MINATO MARU / ENGINE ROOM H1

JS127-ER-H1-03 | CAD implementation amendment | 31 October 2026

CURRENT MODEL SURVEY + ENGINEERING REVIEW

Dimensioned from main f49f22ba82e6 | 31 October 2026 | Units mm; dimensions govern.

Deck-height coordination / new ladder and protected working space

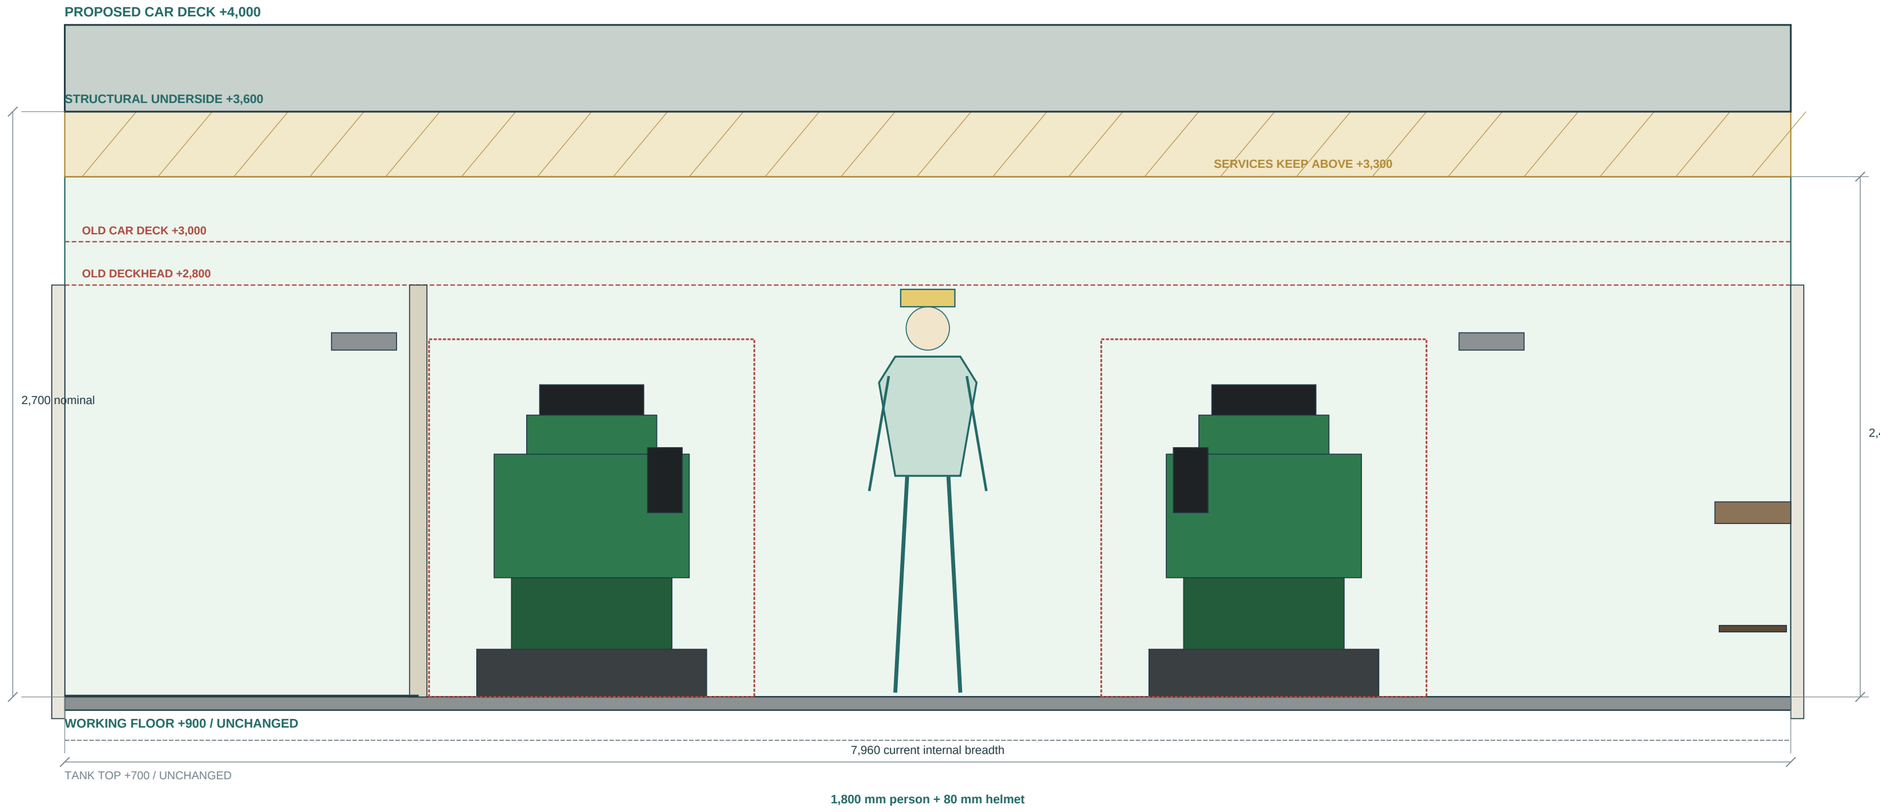
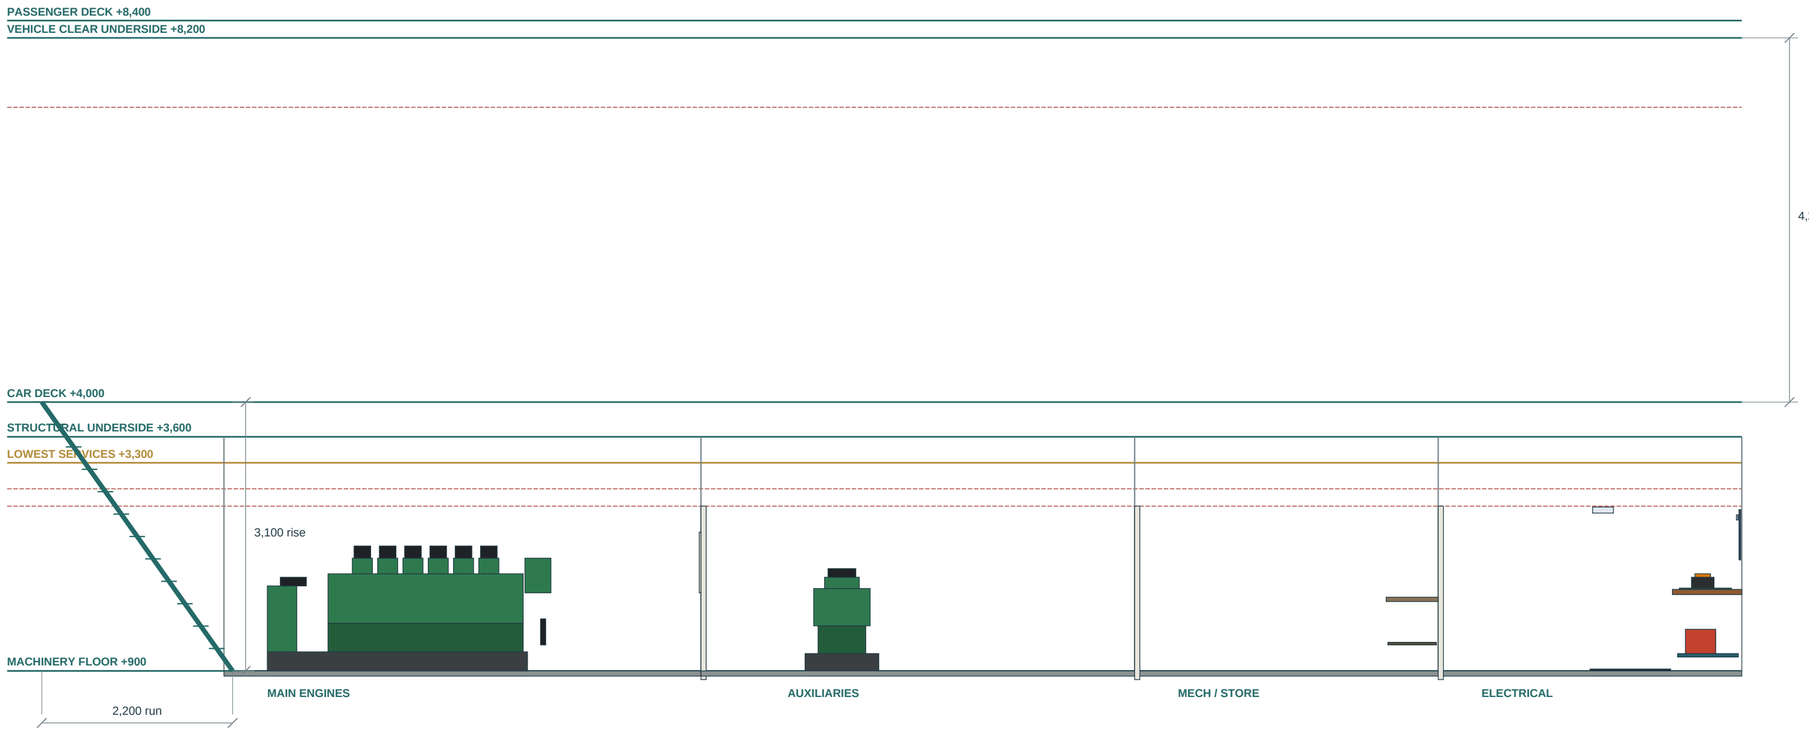
The room becomes 800 mm taller at the structural underside. A separate 400 mm vehicle-deck structural reservation makes the proposed car deck 1,000 mm higher. Raising the decks above by the same 1,000 mm retains the existing vehicle and accommodation clearances.

No ducking in designated standing and working areas. Pipes, trays, valves, handles and insulation must stay outside the clear-height envelope.

Engine and gear centres, foundations, tanks and machinery count remain fixed in this concept. Engine top/removal envelopes still require actual supplier data.

400 mm is a structural planning reservation, not a calculated beam size. If selected structure or services need more depth, increase deck elevations; do not consume the 2,400 mm clear space.

A uniform raised vehicle deck is used to avoid a local machinery hump in the car lanes. Passenger and bridge decks, casings, access, exhausts, vents, ramp hinge/landing arrangements, gangway landings and vertical services need to follow the new levels. Hull breadth, machinery floor and shaft lines are retained as design constraints.

Raise car deck and upper decks by 1,000; raise lowest machinery deck structure by 800. The extra 200 increases the former 200 mm deck envelope to a 400 mm reservation.

Preserve vehicle clear height. Revised overall height, freeboard, lightship/KG, windage, ramp slope, berthing and structure require verification before any game build.

A 3,100 rise with the old 1,600 run would be 62.7 deg. The 2,200 run gives 54.6 deg. A longer flight and landing must be modelled, not a stretched steep ladder.

New machinery volume affects fire suppression and ventilation. Recalculate protected volumes, fan duties and exhaust support. Do not reuse the old 190 m3 CO2 basis.

Baseline accepted paths are not accepted against H1 headroom. Move route design to the new overhead zone and recheck ownership, valves, supports, penetrations and escape.

HEIGHT AND SERVICE ACCESS / 1:20

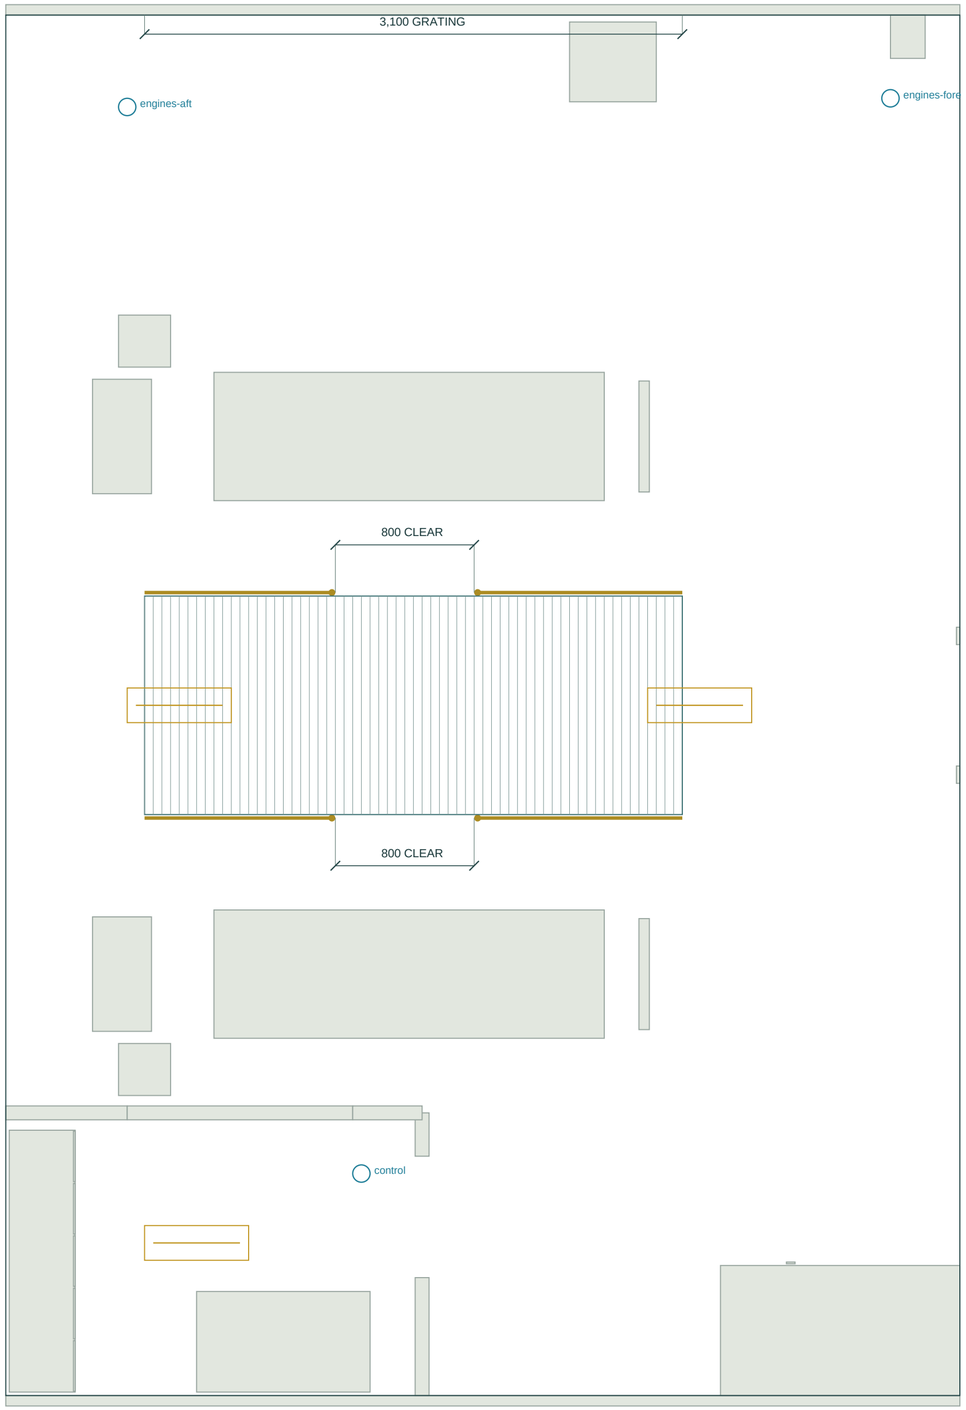
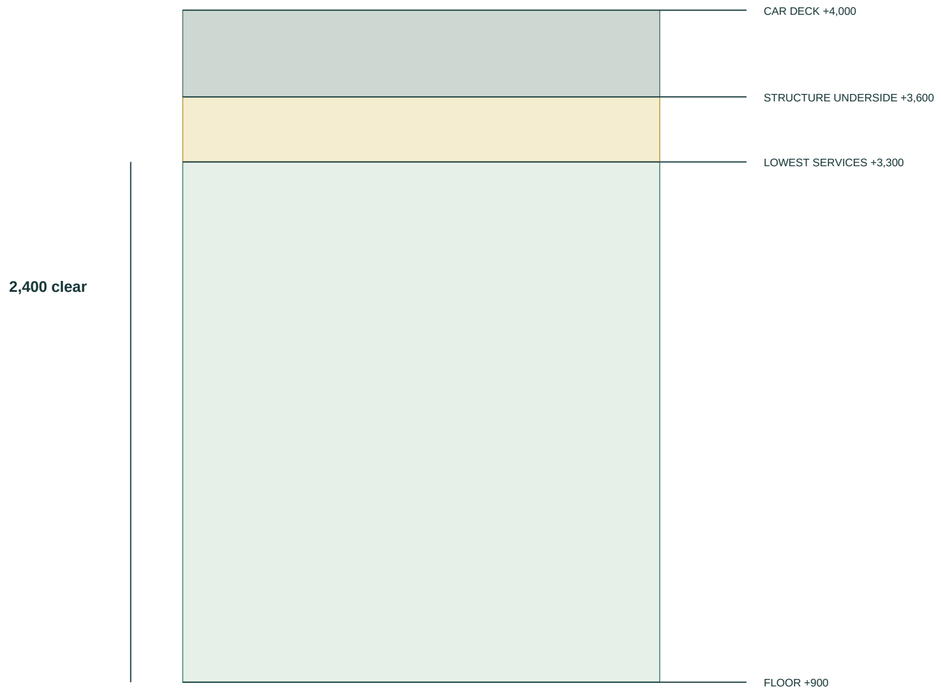
Both inboard engine rails have the service opening. Outside rails remain.

Clear headroom describes the working routes, not the occupied engine volume.

Illustrative pipe previews are omitted; complete service routing remains open.

Structure, stability, berth, fire volume, emergency escape and OEM lifts: OPEN.

LONGITUDINAL SECTION / X forward from transom; Z above keel

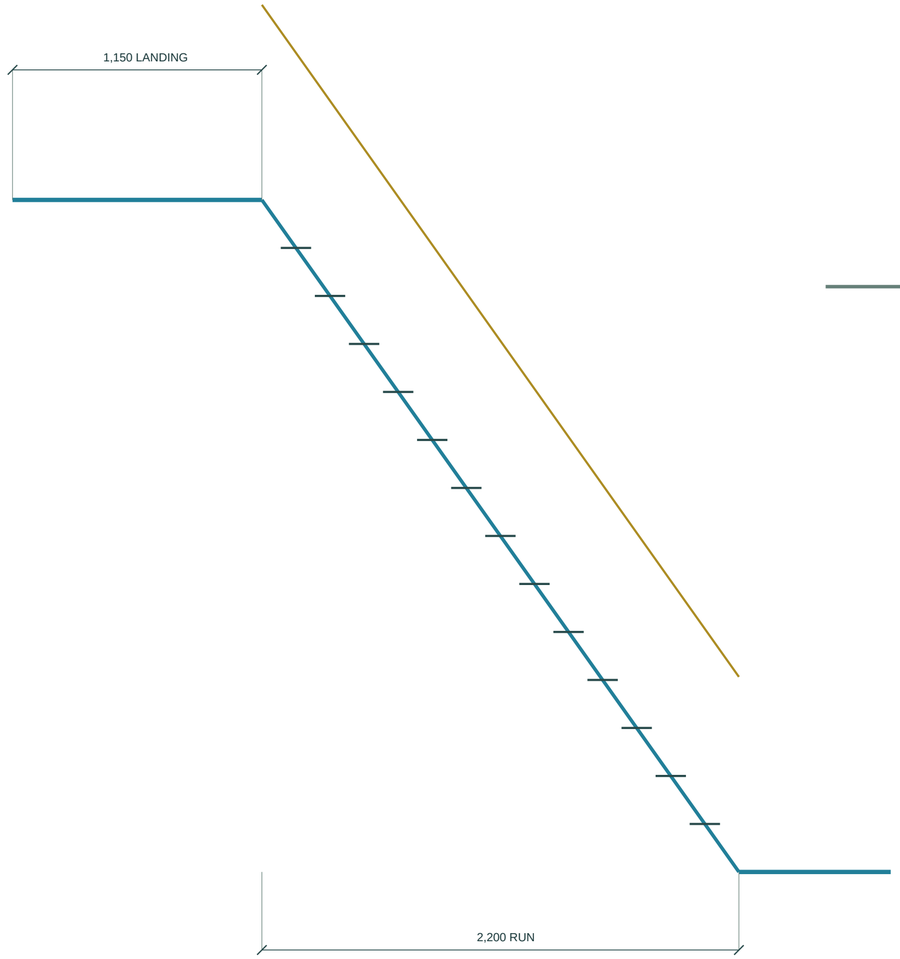
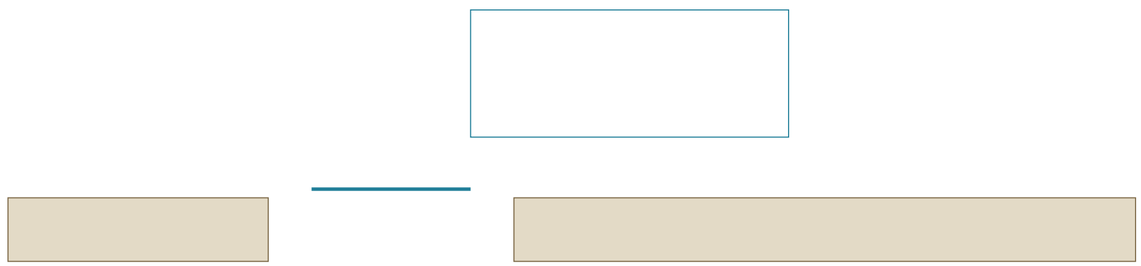
The longer ladder requires a landing behind its head. Relocate the casing P side door; do not enter mid-flight.

Main access only. No protected escape or lifting-route acceptance is implied.

Open car-deck hatch X6,400-9,000. Ladder landing is not a second ER floor.

Walk down and back up using the new door and landing, not old X6,900.

Whole-vessel and protected emergency escape design remain open.

COORDINATED GEOMETRY / LIMITS

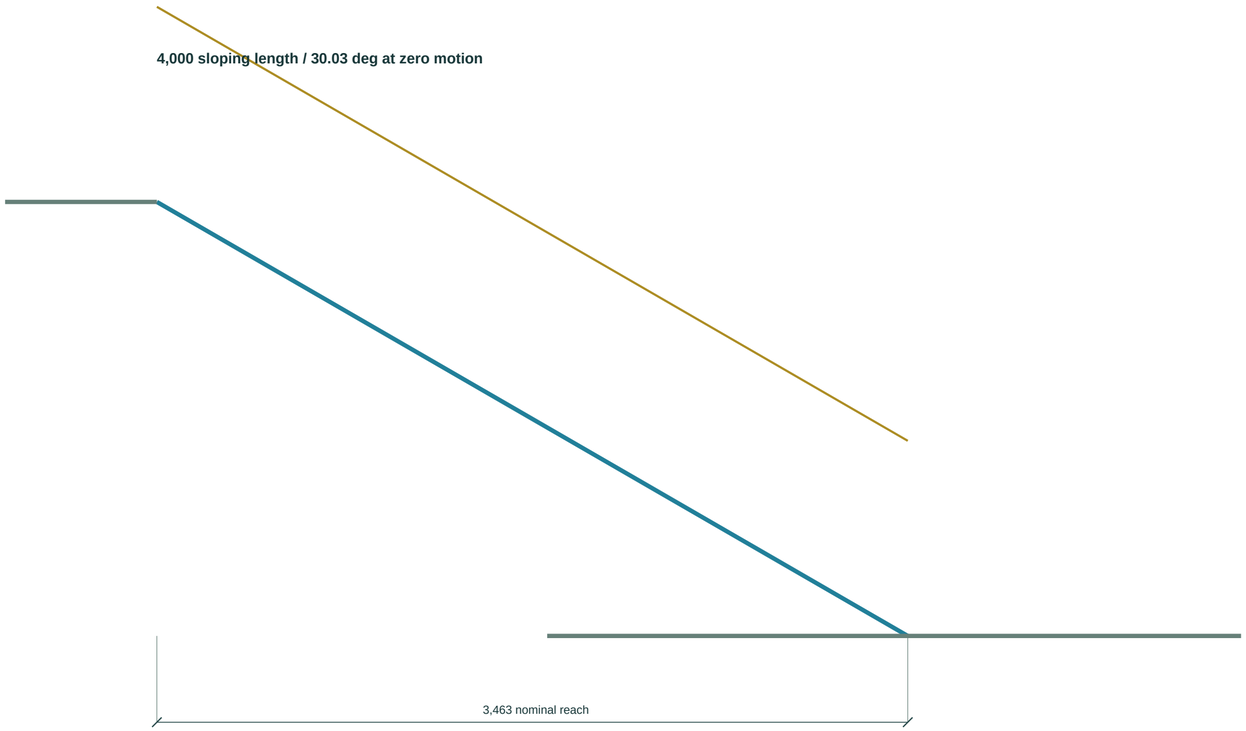
Raised vehicle deck: extend the boarding gangway rather than leave an unsupported step from the pier.

Fold upright under passenger deck; 4,200 clear zone reserves 200 margin.

Pier landing, clear pedestrian route, toe contact: verify in the walk tests.

Hoist capacity, stow restraints, structure, tides and real access: OPEN.

Main engine room / equipment and working clearances

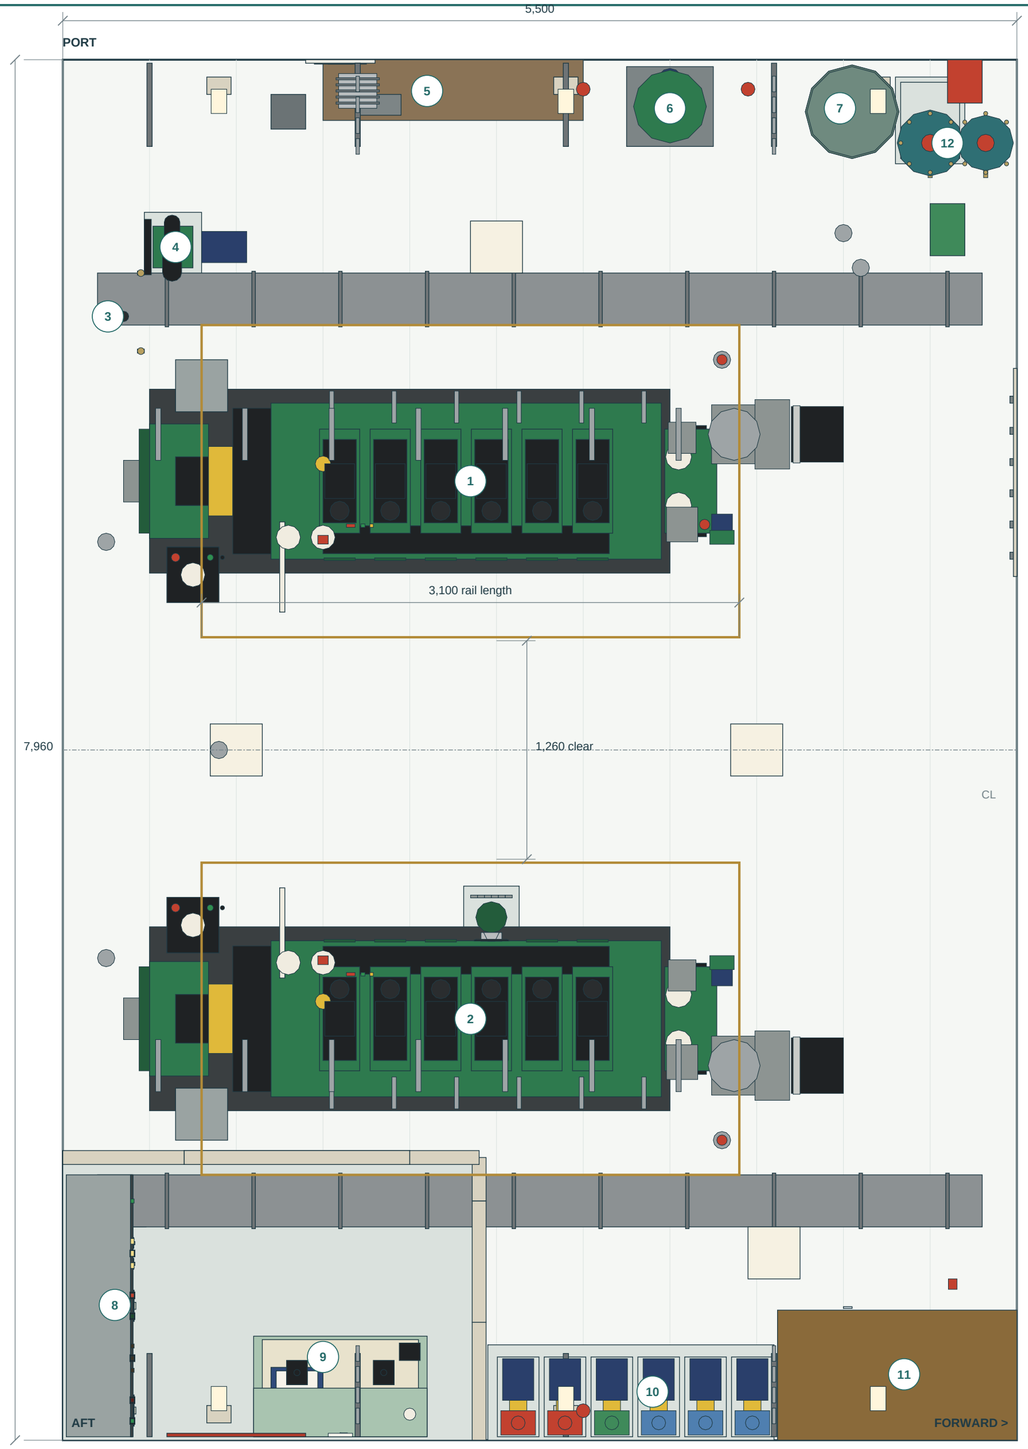
Current bedplates X=9,000-12,000; centres Y=+/-1,550. Actual fittings are projected from source; manufacturer installation dimensions remain unverified.

Two 150 L receivers and compressor No.1 aft to port. Receiver reliefs, drains, certified start capacity and complete piping still need detail.

Workbench, fuel purifier and oily-water separator. Keep machinery opening and filter/basket withdrawal space; the picture alone does not prove service access.

MSB aft, engine console and log desk along the side. Current booth has one modelled doorway; protected independent escape is unresolved.

Service tank remains forward starboard. Both sea-water suctions/strainers must remain accessible. Tank, hot exhaust and switchboard routes must be coordinated.

Closed yellow rail loops currently surround both engines. No gate is modelled; a maintainable machine cannot rely on climbing a rail. A correction must retain guarded edges and provide deliberate service access.

Auxiliary machinery room / generators and service plant

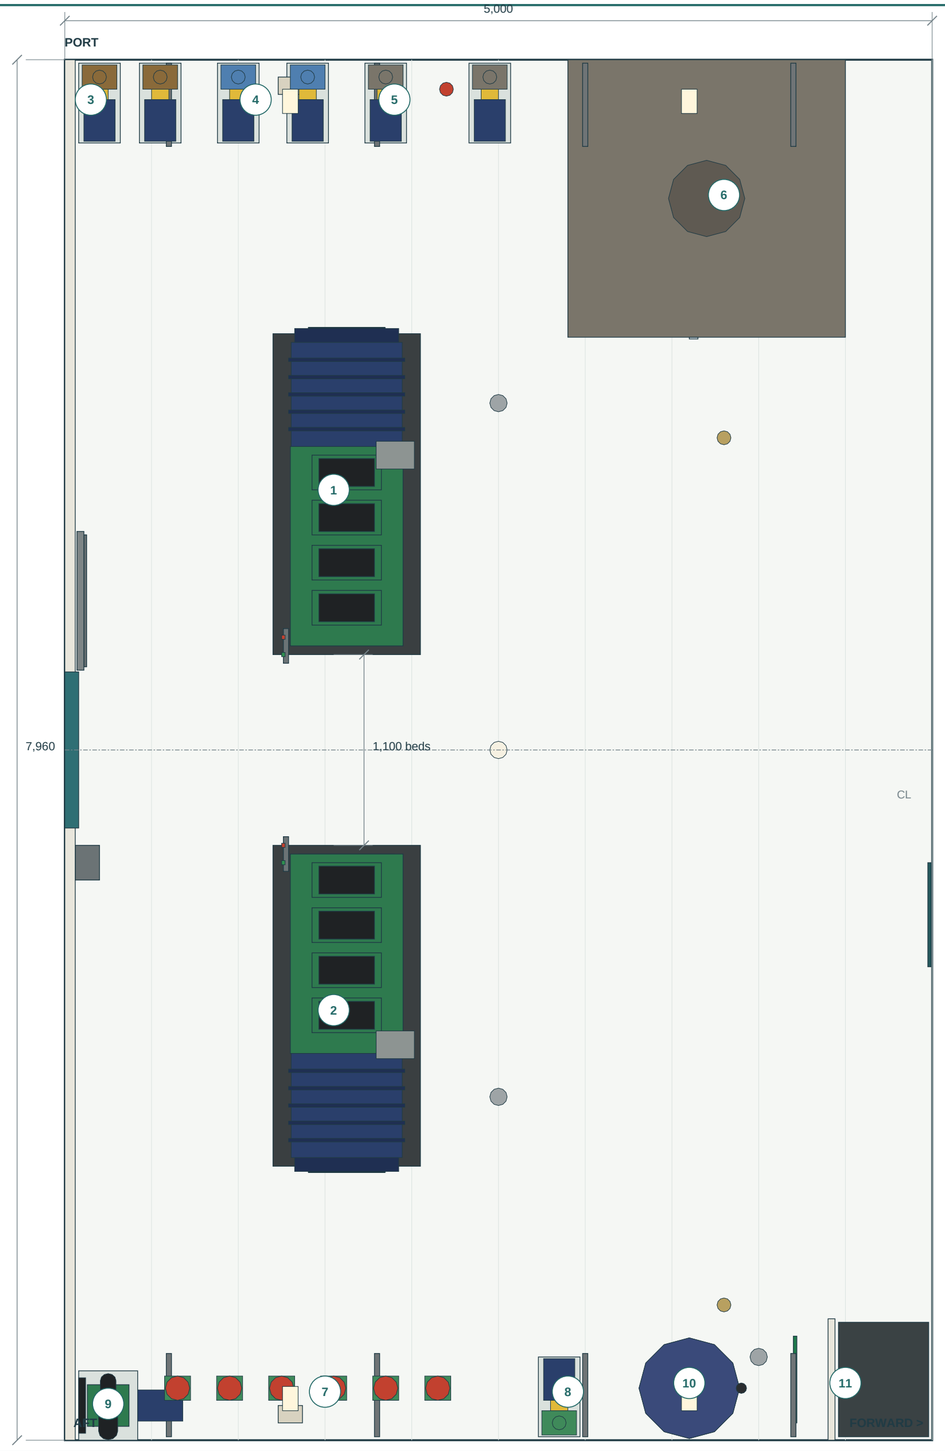
Current set beds X=15,200-16,050, Y=550-2,400 and -2,400 to -550. Inboard dynamic fittings leave a smaller declared 1,000 mm working aisle.

Two separate pumps remain. Dedicated suction/discharge interfaces and control/bypass arrangements need the unpublished fuel C1 design to be reviewed.

Ballast manifold, ballast pump, compressor No.2 and 300 L hydrophore vessel. Access to valve spindles, motor withdrawals and pressure-vessel inspections remains a hold.

A 700 mm-wide model trunk is drawn. It is an existing representation, not a proved protected exit to a safe deck. Route and fire-boundary details must be completed.

Door at X=14,000: 800 mm nominal wide. Door at X=19,000: 750 mm nominal wide. Do not route machinery removal through these openings unless the dismantled item and rigging fit.
